ADDENDUM NO. 1

**HANOVER COMMUNITY SCHOOL CORPORATION - NEW RESOURCE
CENTER AND RELATED WORK
Cedar Lake, IN 46303**

This Addendum consists of page ADD 1-1 and attached Addendum No. 1 from Gibraltar Design dated May 27, 2021 and consisting of 5 pages and 48 drawings.

DRAWING
STRUCTURAL FOUNDATION
PLAN

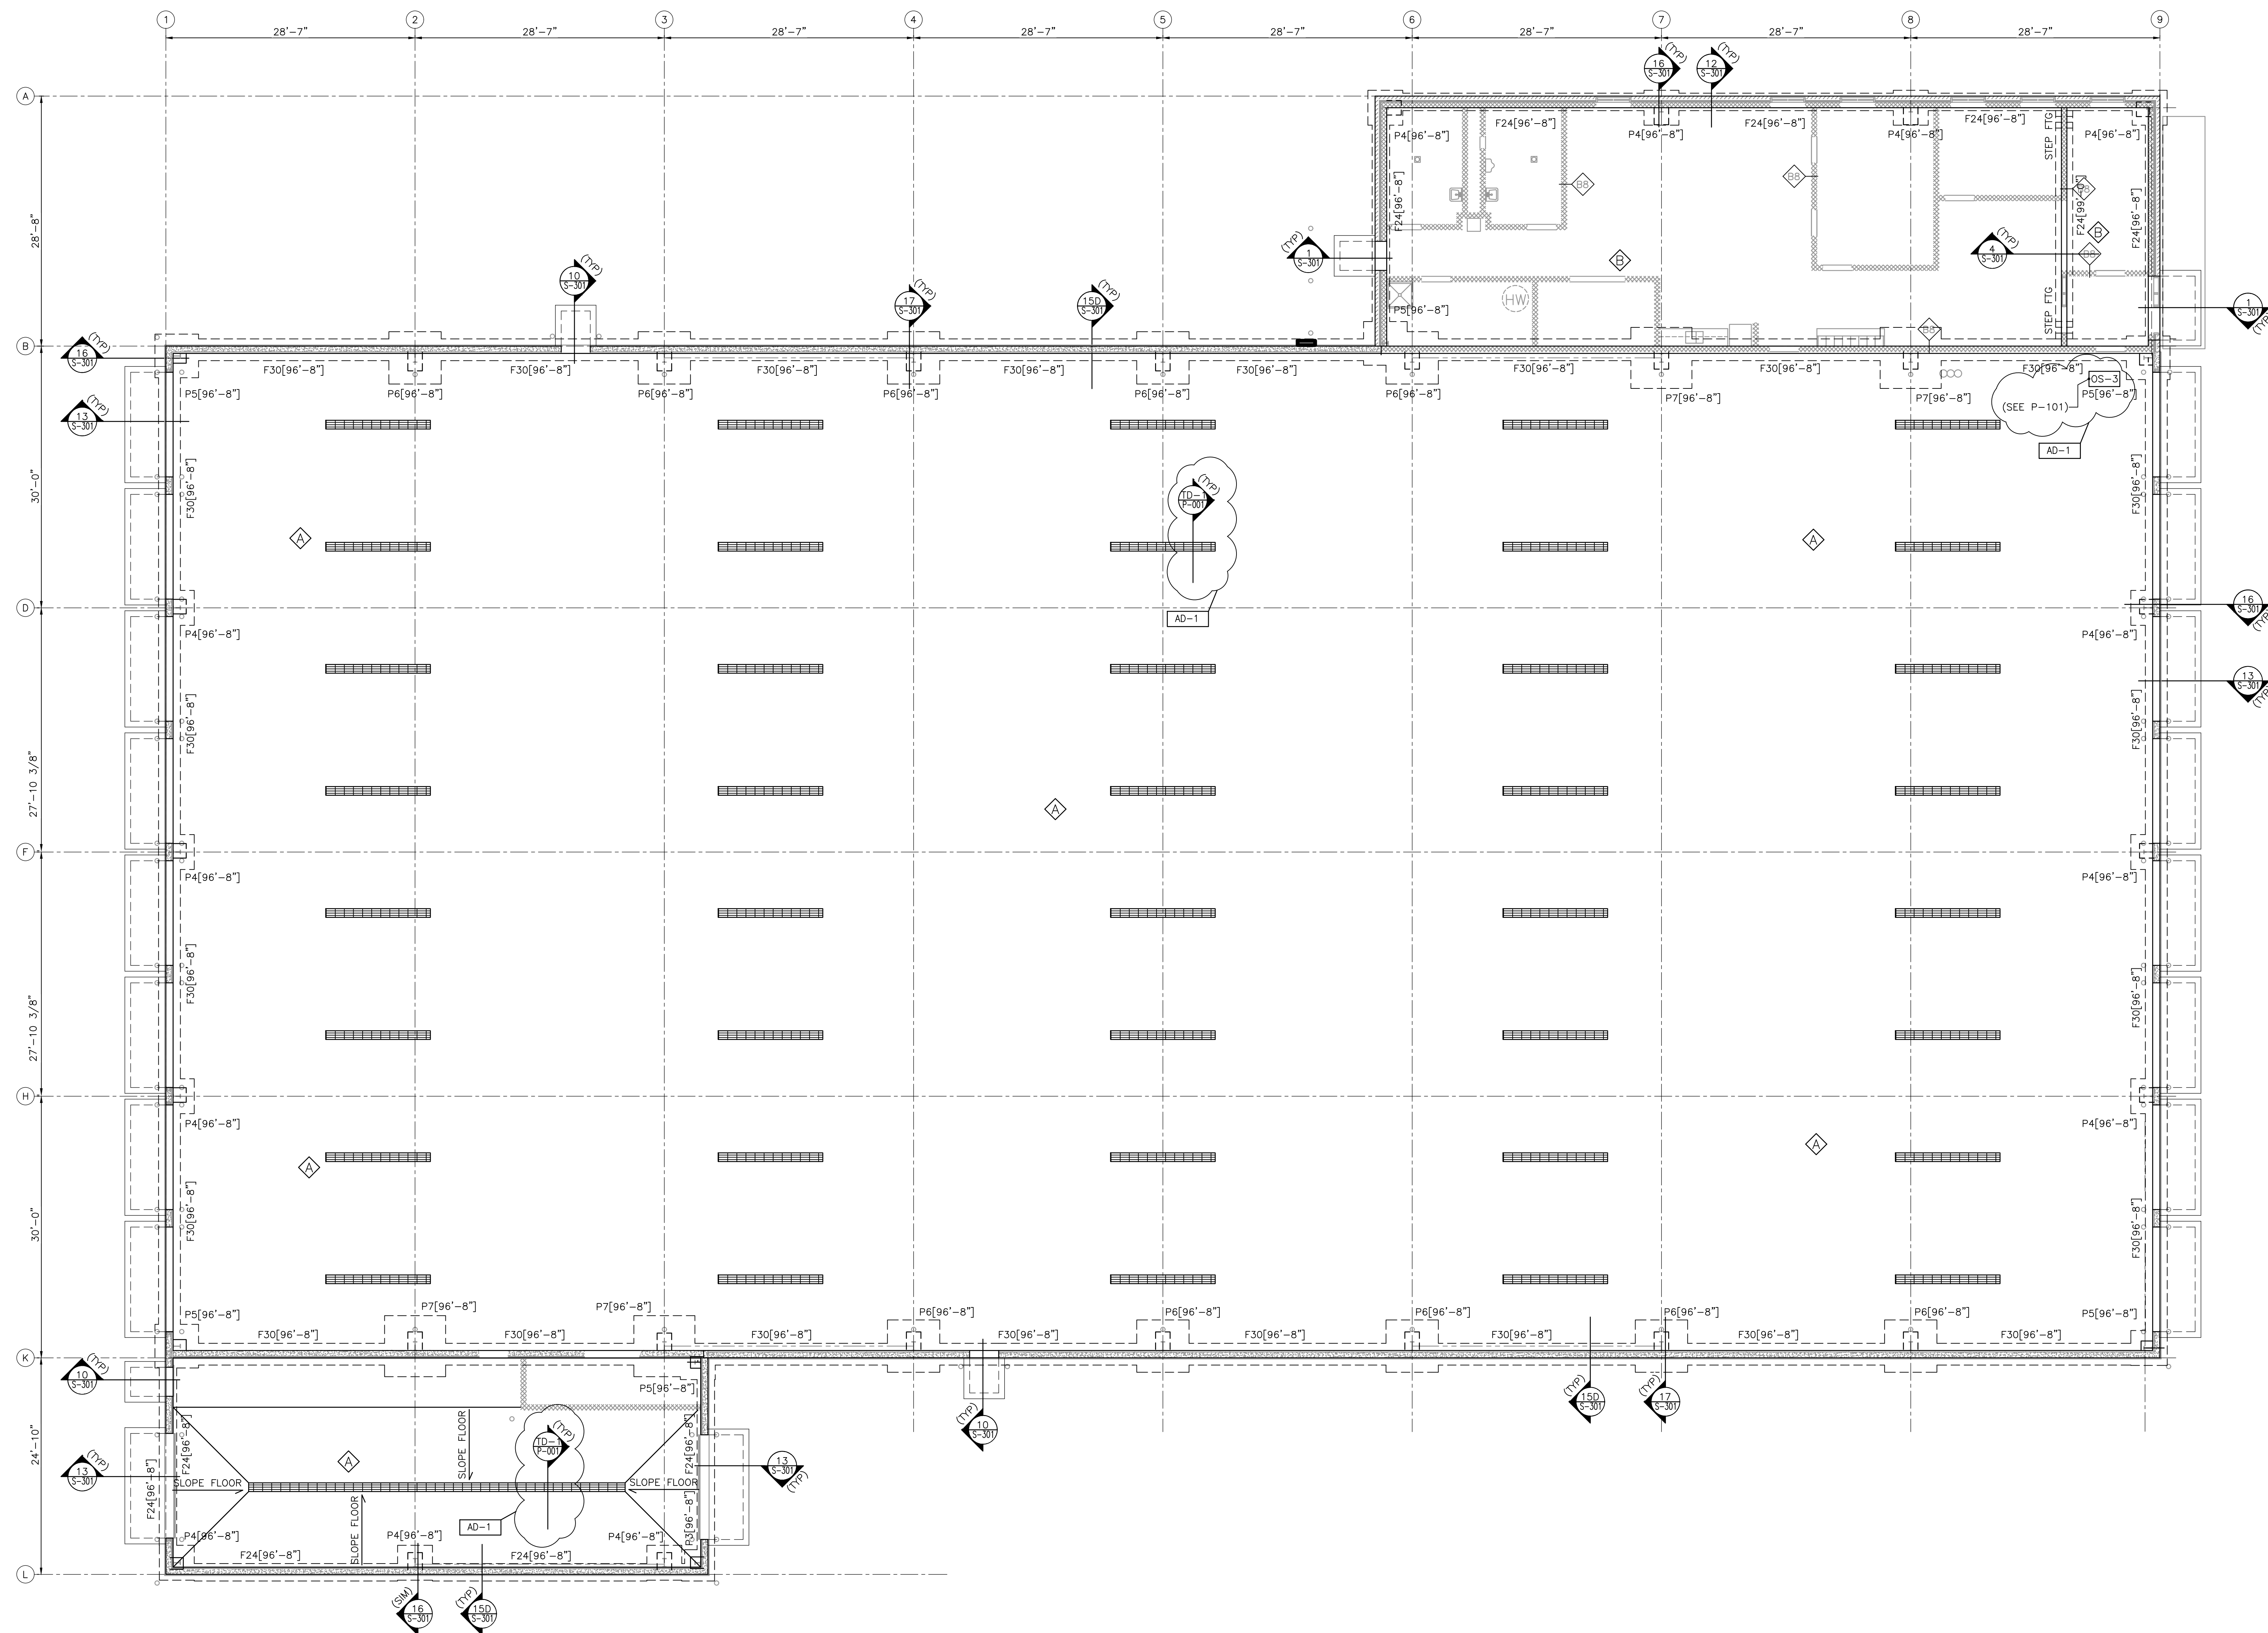
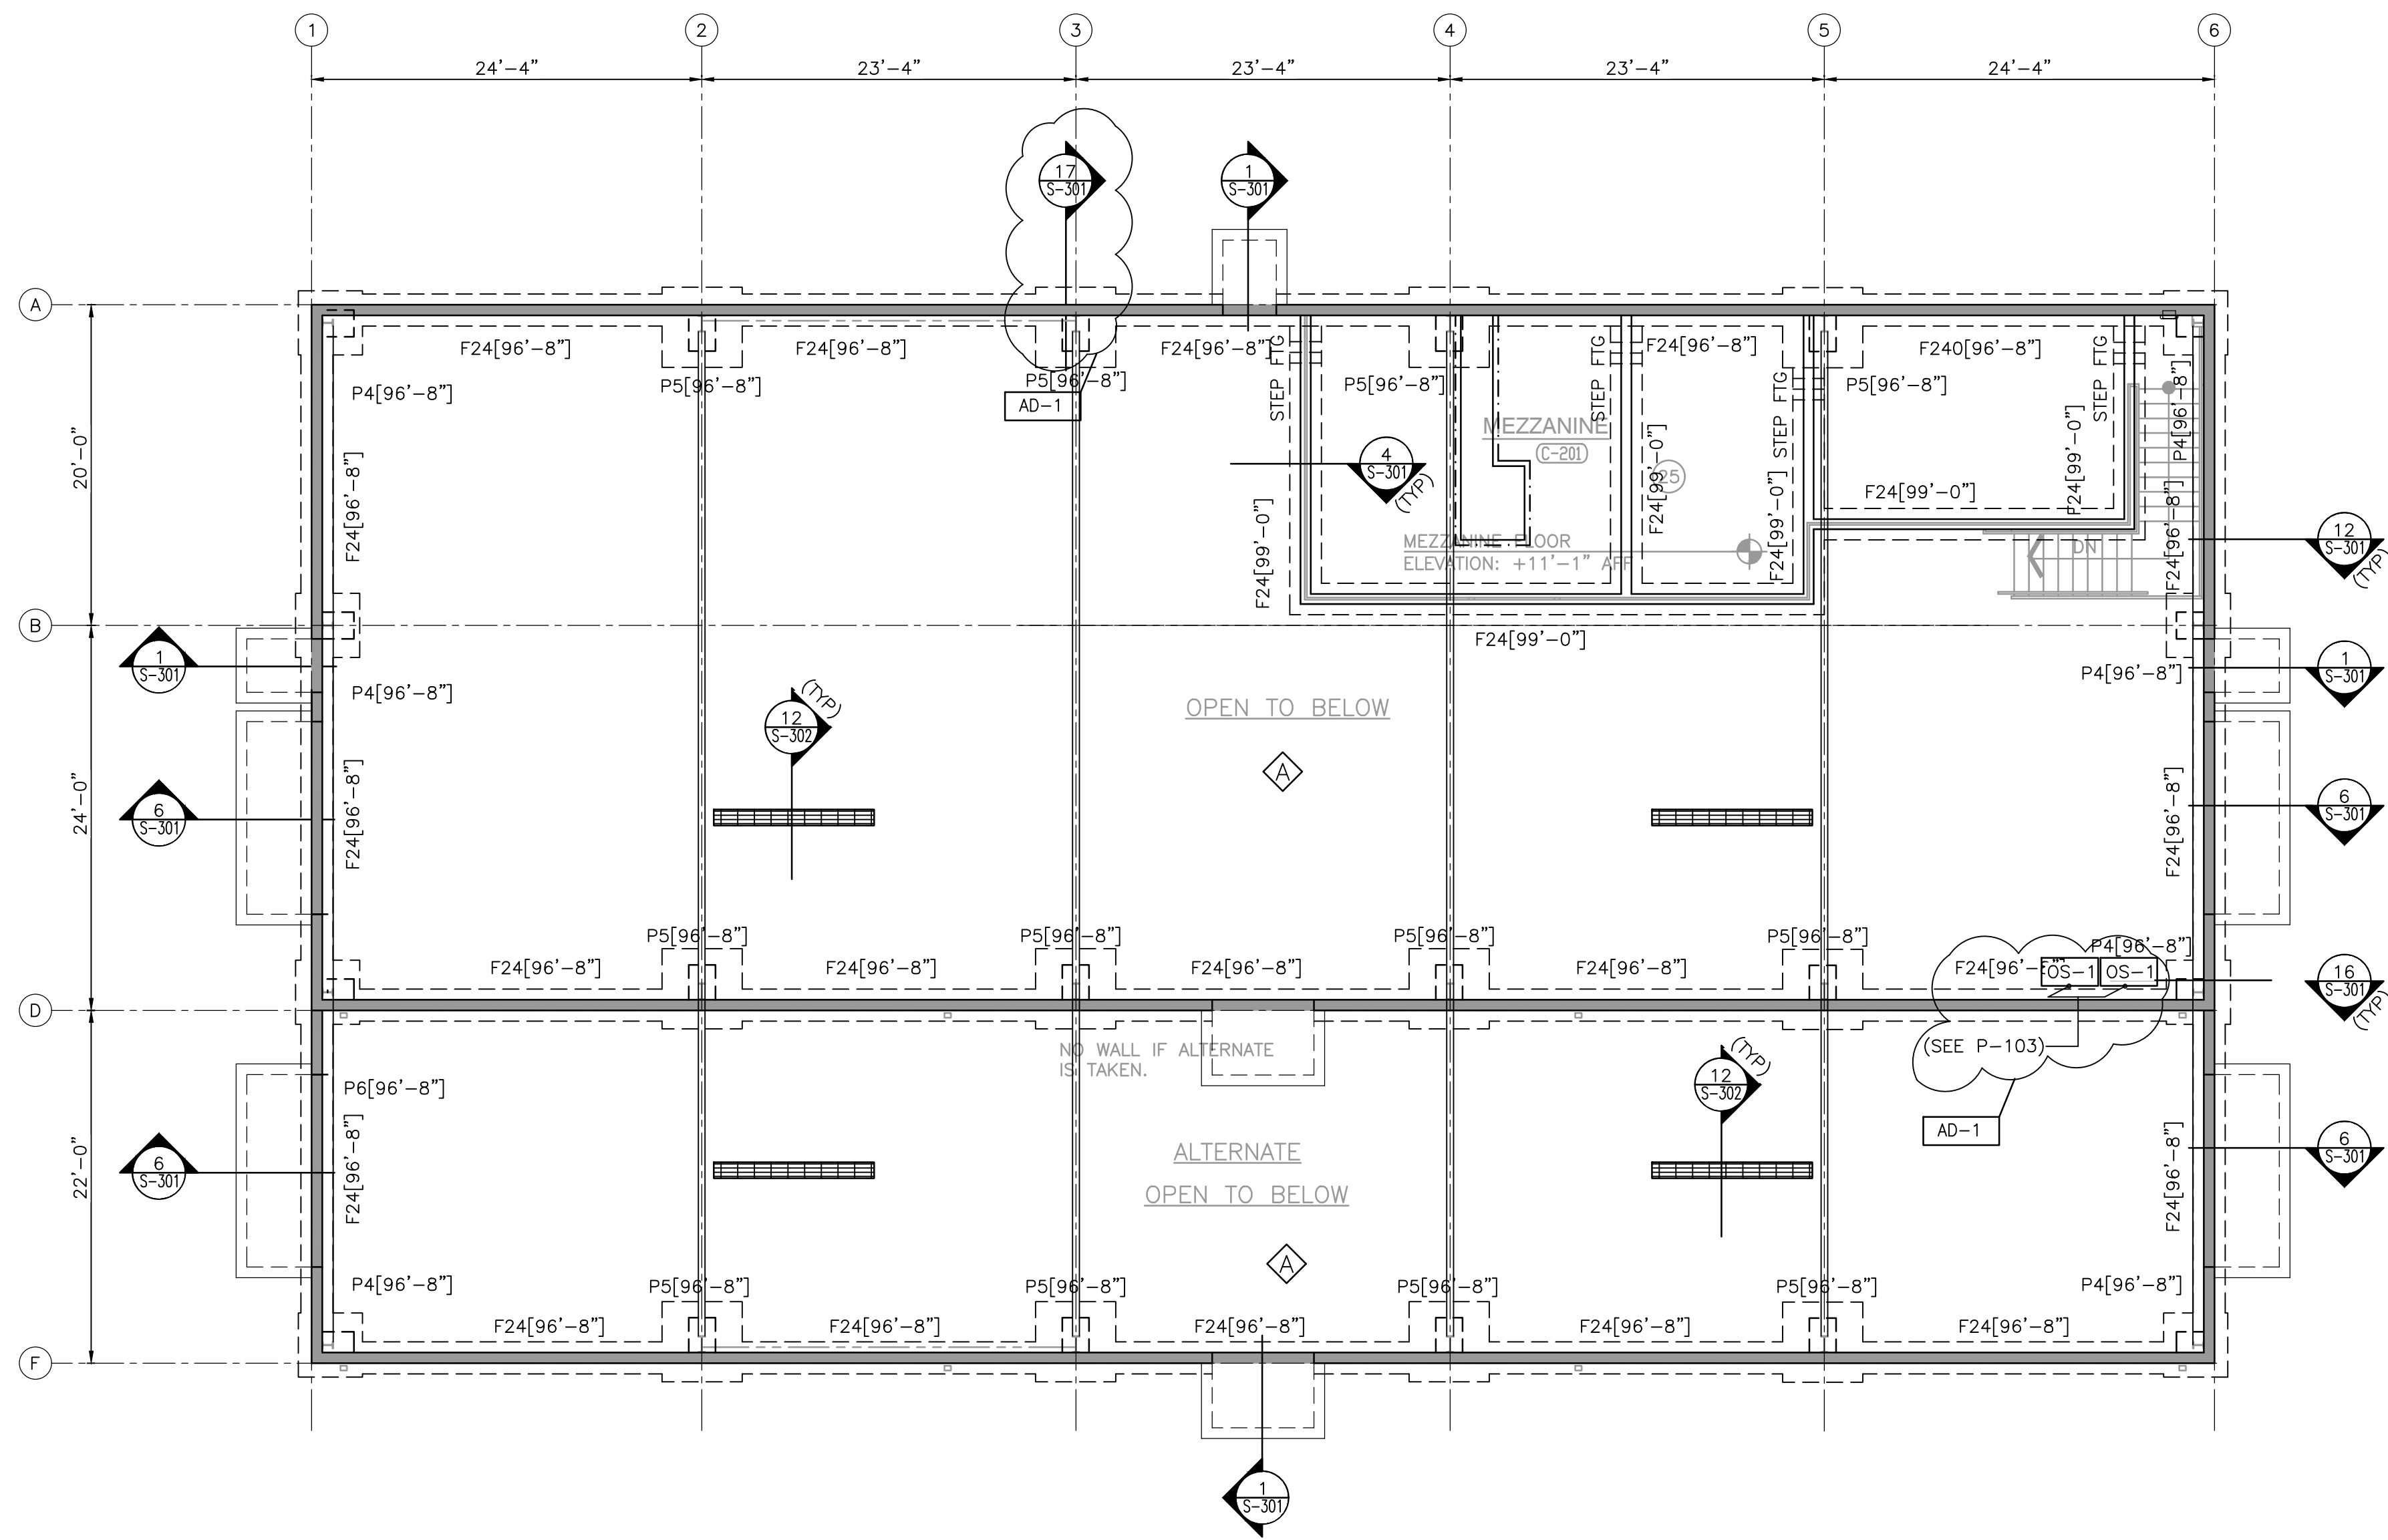
1. Floor drain section cuts revised to be coordinated with plumbing plans.
2. Add oil separator floor pit to the slab plan and coordinate with adjacent footing depths by verifying size with plumbing plans.
3. Add mechanical equipment exterior concrete support pads.
4. On SB101 only, revise section cut 16B/S-301 near Grid A-3 to 17/S-301.
